APPLICATION NO.	FILING DATE	FIRST NAMED INVENTOR	ATTORNEY DOCKET NO.	CONFIRMATION NO.
10/082,500	02/25/2002	Cheng-Lien Chiang	BDG005-3	3761

Office Action Summary

DETAILED ACTION

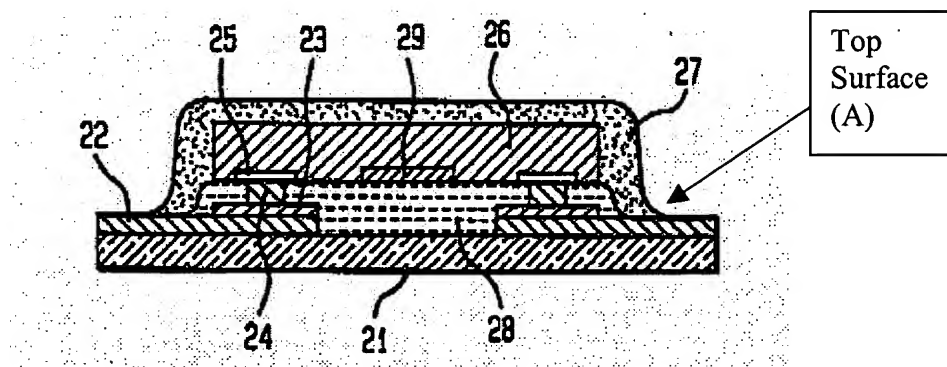
- iv. Regarding e.g. claims 9, 19, 28 and 29, Nakamura et al. discloses in e.g. Fig. 2 the device being devoid of an electrical conductor that extends through opposing surfaces of the second housing portion. The examiner reads the term "electrical conductor" as referring to an additional structure, separate from the conductive trace, because if the term

“electrical conductor” were to read on the “conductive trace”, the claim would raise 112-1st new matter issues.
